# CITY OF ALBUQUERQUE

**RE: Loids Collision  
Conceptual Grading and Drainage Plan  
Engineer's Stamp Date 5-4-2016 (File:B18D010)**

Project Title: Loids Collision Building Permit #: \_\_\_\_\_ City Drainage #: B18D010

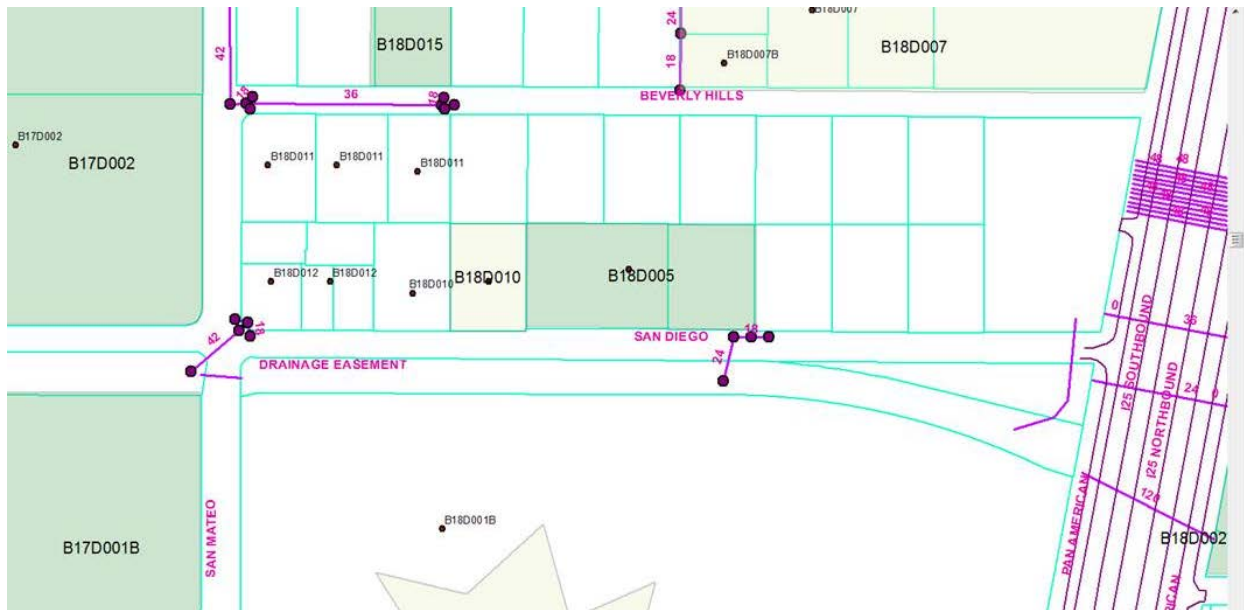
San Diego has been improved upstream and downstream of your site with inlets that tie directly into the North La Cueva hard channel. I would need to understand if any inlets need to be planned along the frontage of your site (B18D010). In the best case scenario, the inlets to the west have enough capacity (or capacity can be added) to accept the additional discharge (B18D012). I looked through the drainage report for the site to the west and it looks like that *may* be the case. However, if there is not capacity available (or not feasible to add capacity), then a direct connection to the channel might have to be planned and coordinated with AMAFCA.

Again, I think there is some capacity available, but I have not reviewed that file in depth to know for sure. I would need some preliminary evidence to be included in the submittal (you can just submit a DRB Supplement) prior to accepting the Infrastructure List. See below from our GIS for your reference/research:

Sorry for not getting back to you sooner. We have reviewed the downstream drainage files and verified site conditions. As per the attached report, there is a double "A" inlet and a double "C" inlet at the intersection of San Diego and San Mateo. They connect to a 42" pipe that discharges to the channel. As shown by the report, this infrastructure was sized and designed to accept developed runoff from Lots 32-29, which includes our two lots (30 and 29). The two lots in the subject report (32 and 31) drain internally to the 42" outfall, and the two double inlets pick up the street flows and discharge from Lots 30 and 29).

2016.015.2  
13678  
05-04-2016  
CONCEPTUAL GRADING PLAN

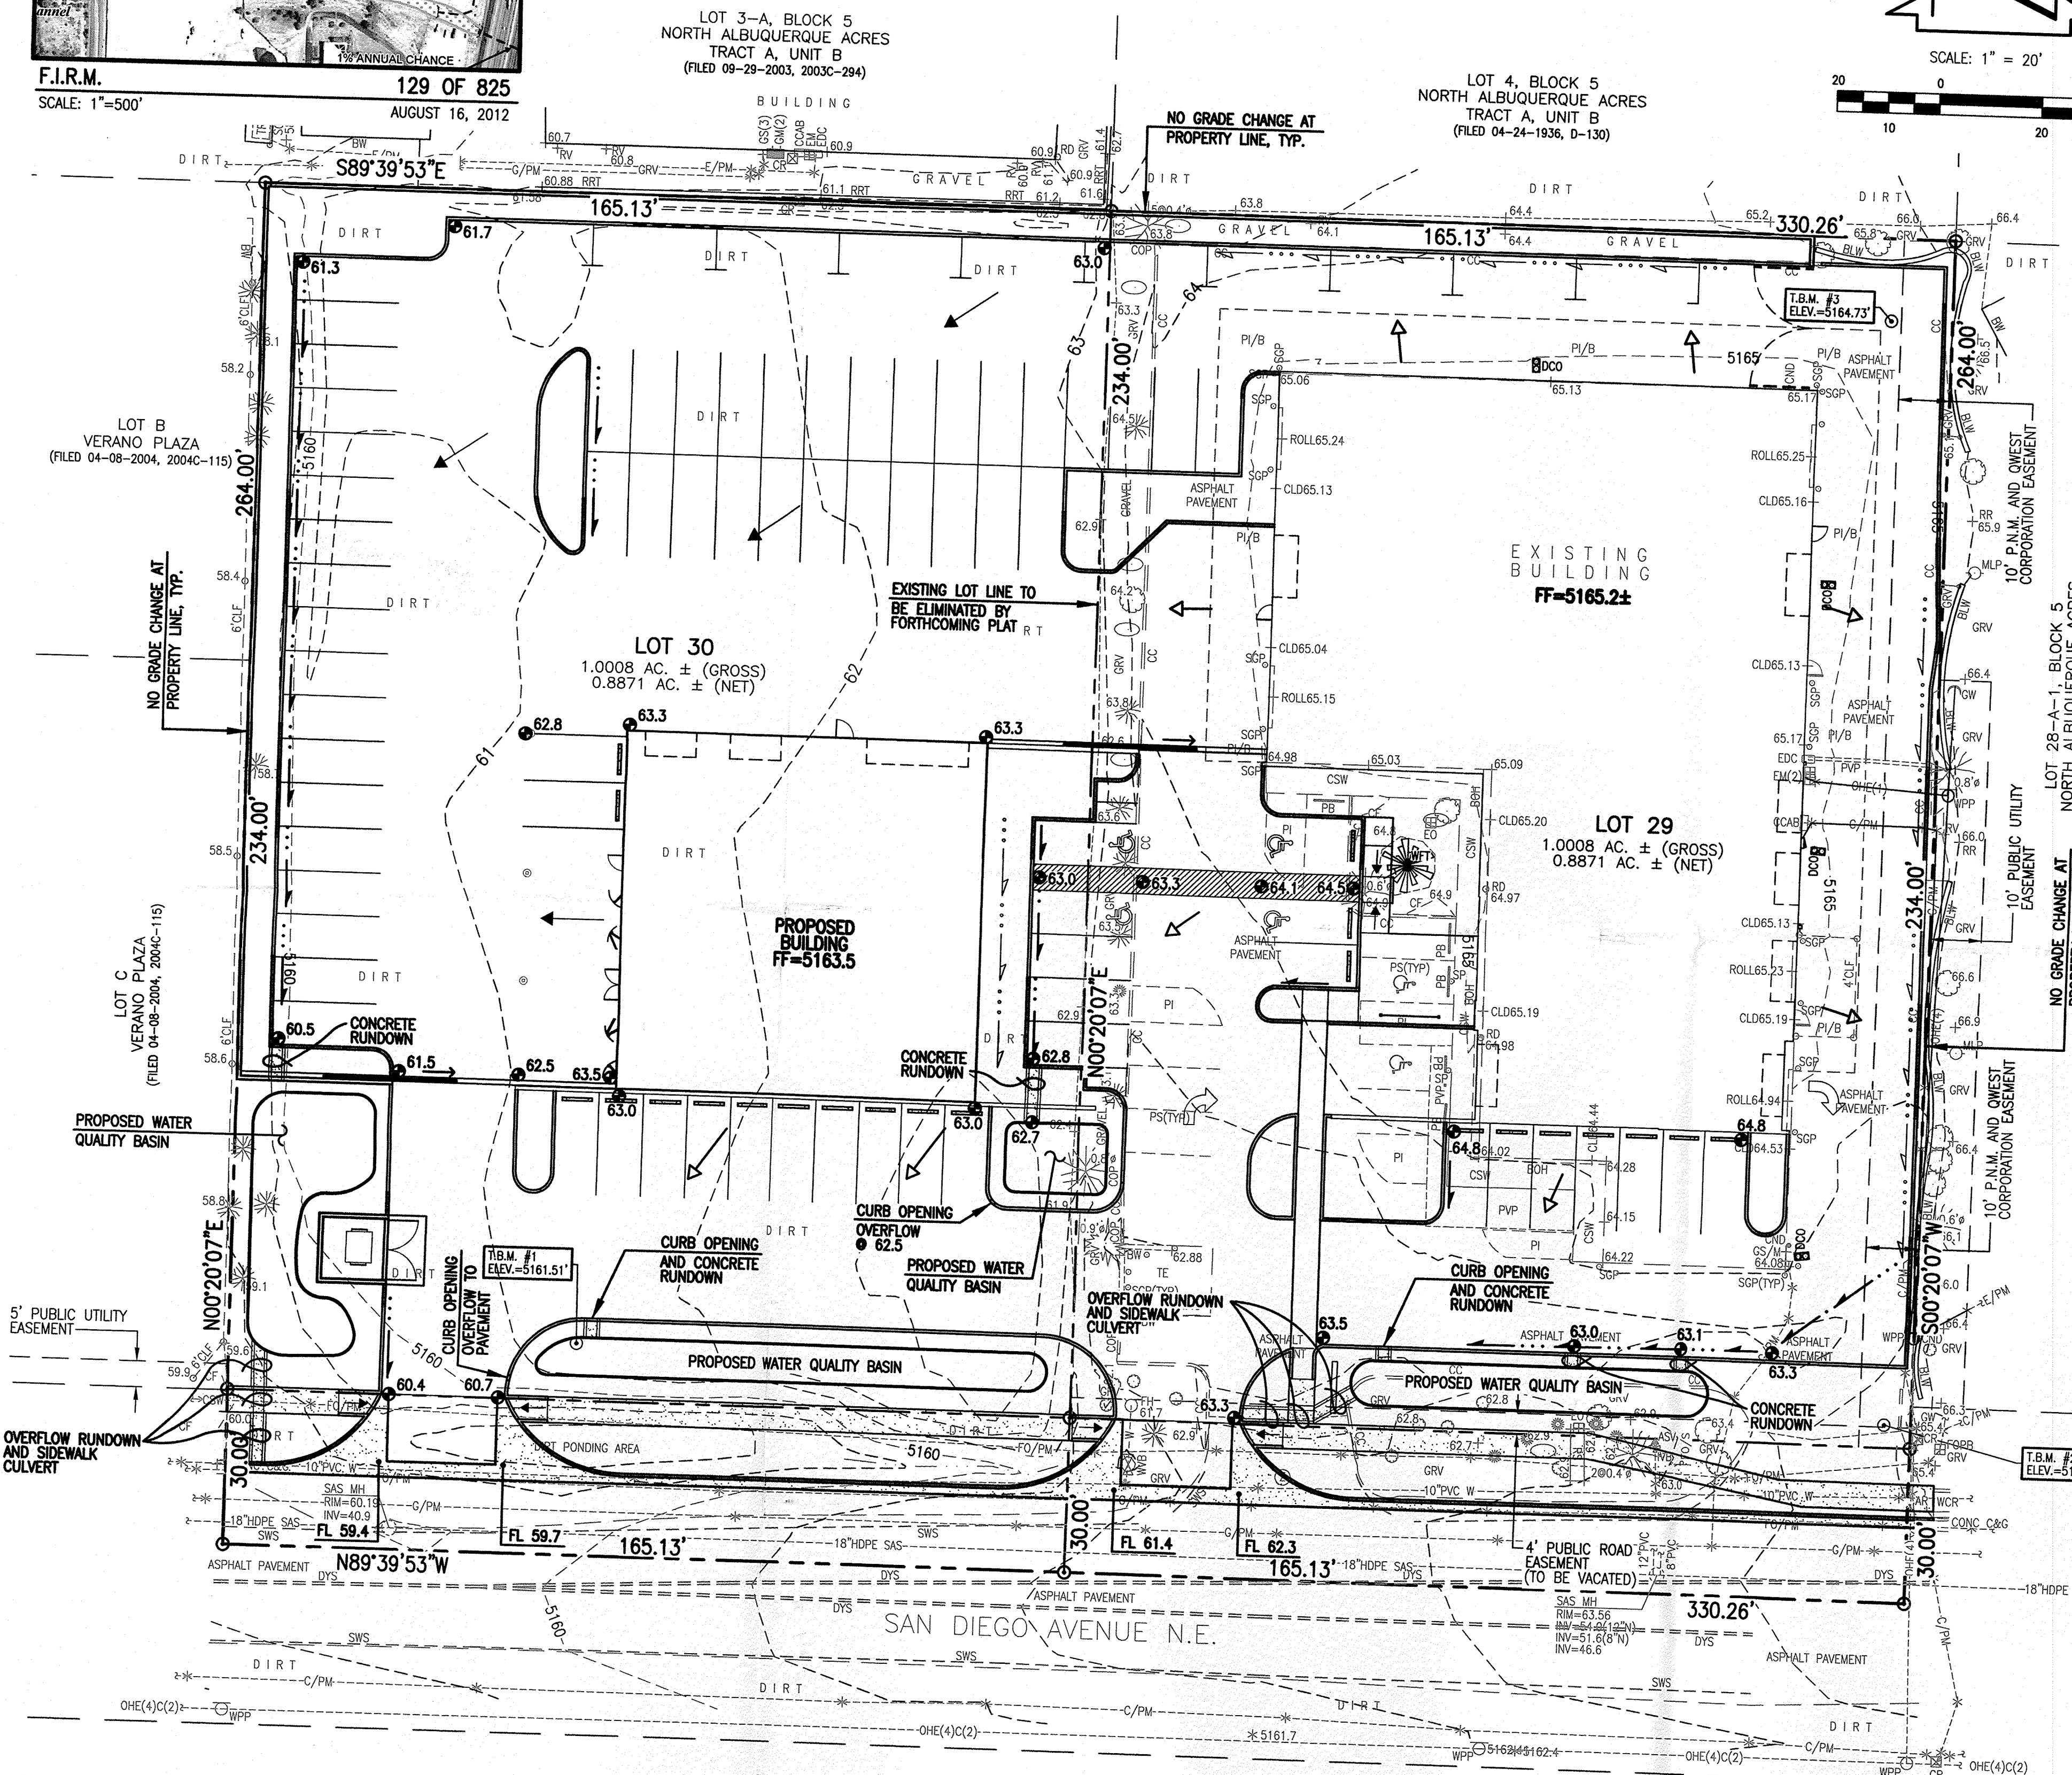
Please be aware that since it appears that the site is over 1-acre, an approved Erosion and Sediment Control Plan will be required prior to Hydrology's approval of the submittal for Building Permit approval.
